PINE VALLEY SUBDIVISION, SECOND ADDITION

APPLICATION NUMBER 25 DATE April 21, 2005

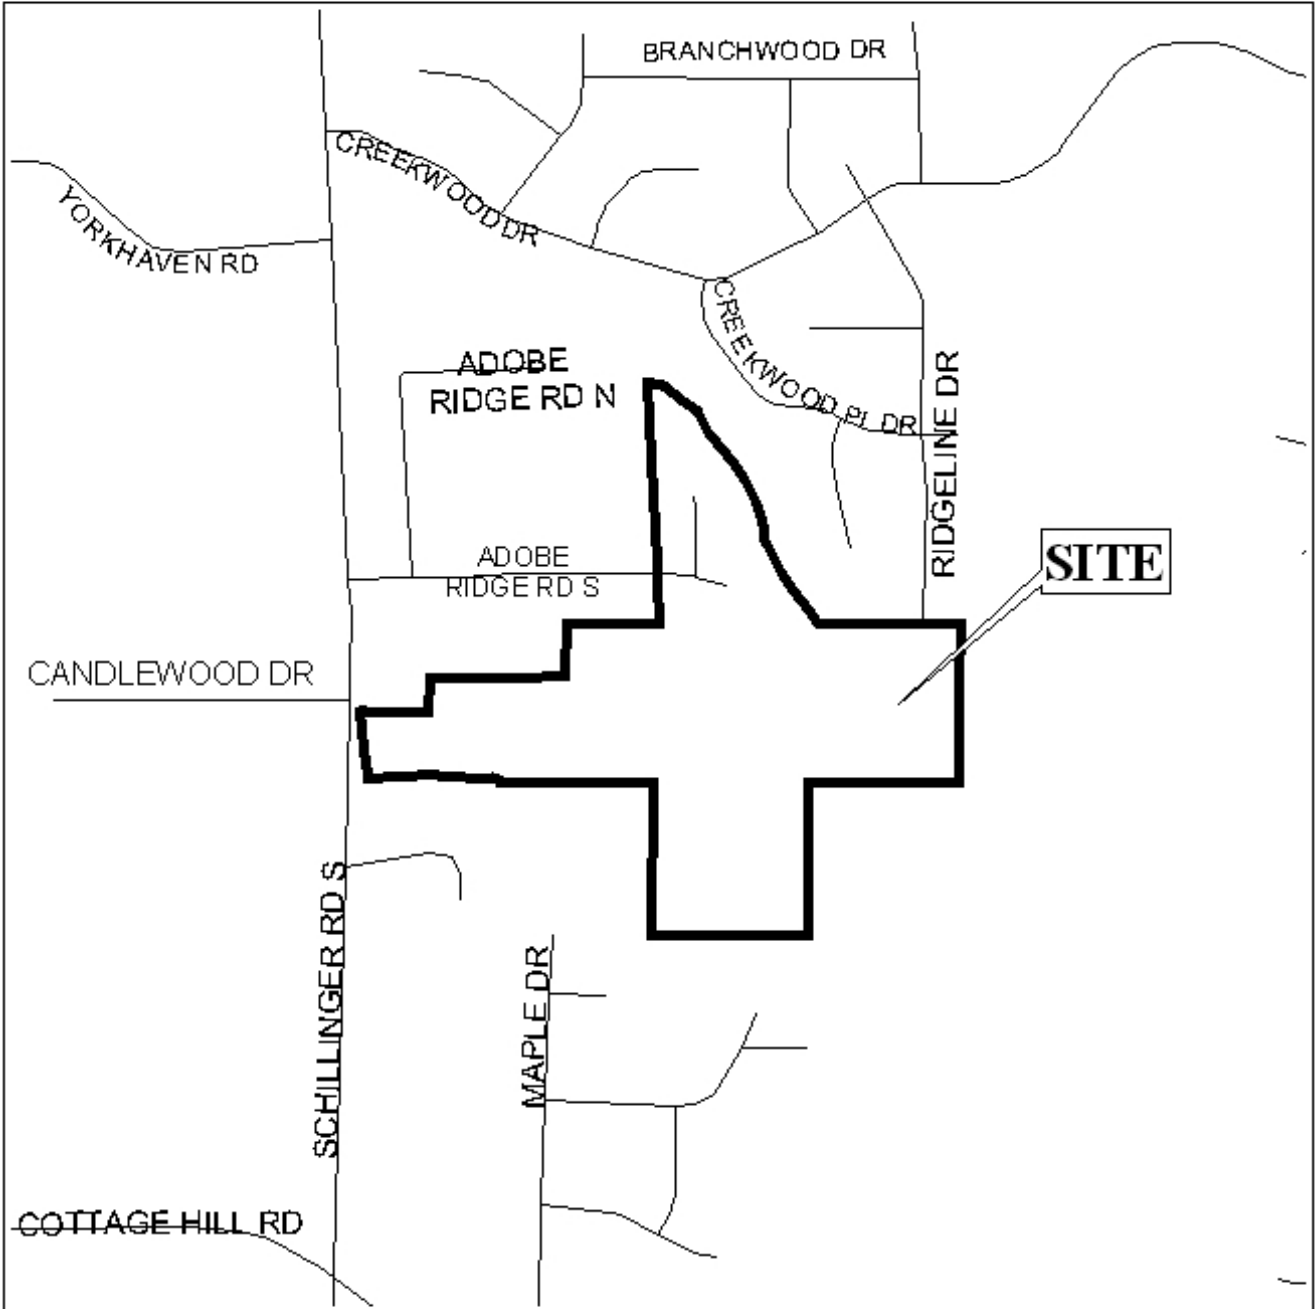
The site fronts Schillinger Road, a planned major street with a right-of-way varying from 100'± to 150'± adjacent to the site, which complies with the Major Street Plan. As a means of access management, Lot 10 should be denied direct access to Schillinger Road.

The subdivision involves the creation of a new street, which should be constructed to County Engineering standards and dedicated. A temporary turnaround should be provided at the East end until the rest of the street is constructed.

The required 25' building setback line is not shown, but would be required on the final plat. It should also be noted that in four places, the bearings on the drawing do not correspond to those in the legal description; this should be corrected on the final plat.

The plat meets the minimum requirements of the Subdivision Regulations and is recommended for Tentative Approval, subject to the following conditions: 1) the placement of a note on the final plat stating that Lot 10 is denied access to Schillinger Road; 2) the construction and dedication of the new street; 3) the provision of a temporary turnaround at the East end of the new street; 4) the depiction of the 25' building setbacks on the final plat; 5) the correlation of bearings in the legal description and on the drawing on the final plat; and 6) the placement of a note on the final plat stating that any lots that are developed commercially and adjoin residentially developed property must provide a buffer, in compliance with Section V.A.7 of the Subdivision Regulations.
